Subject: Initial Application for Amendment 3 to the Standardized Advanced NUHOMS®  
Certificate of Compliance No. 1029, Docket No. 72-1029

In accordance with 10 CFR 72.244, Transnuclear, Inc. (TN) herewith submits this application to amend Certificate of Compliance (CoC) 1029 for the Standardized Advanced NUHOMS® System.

Amendment 3 adds the NUHOMS® 32PTH2 system, which consists of a new transportable Dry Shielded Canister (DSC) designated the 32PTH2, stored in a modified version of the currently licensed Advanced NUHOMS® AHSM horizontal storage module, designated the AHSM-HS.

**Figure 4-1 Minimum Spacer Disc Ligament Widths for 24PT1 and 24PT4-DSCs**

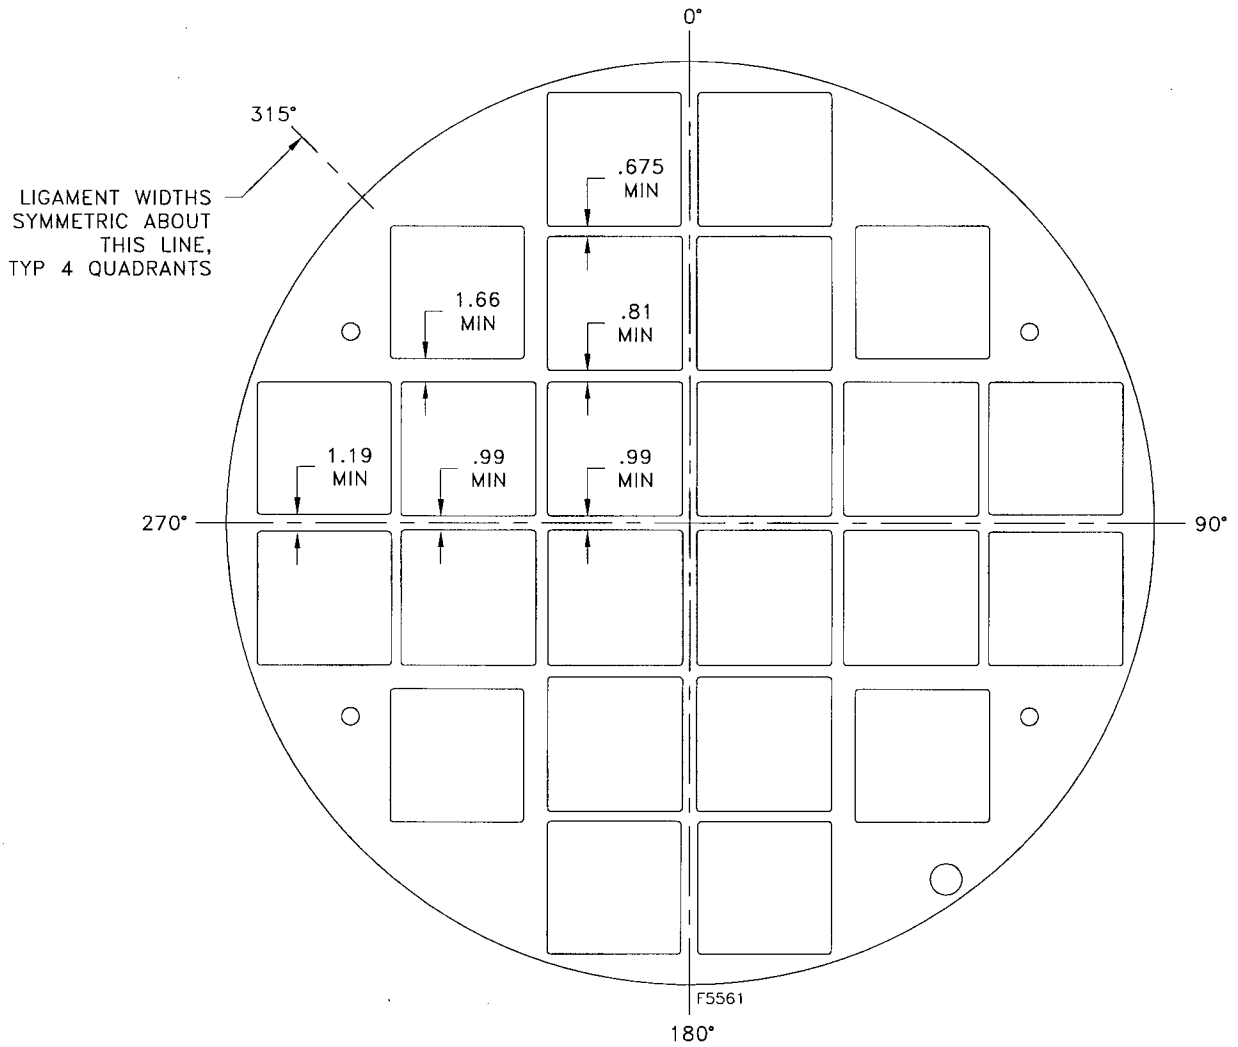
4.2.3	<p>Added discussion regarding 32PTH2 DSC basket types and requirements for neutron absorbers.</p>
4.2.5	<p>Added information regarding the 32PTH2 DSC not requiring fuel spacers.</p>
Figure 4-1	<p>Added an explanatory note regarding ligament width dimensions, and expanded the figure title to indicate applicability to the 24PT1 and 24PT4-DSCs.</p>
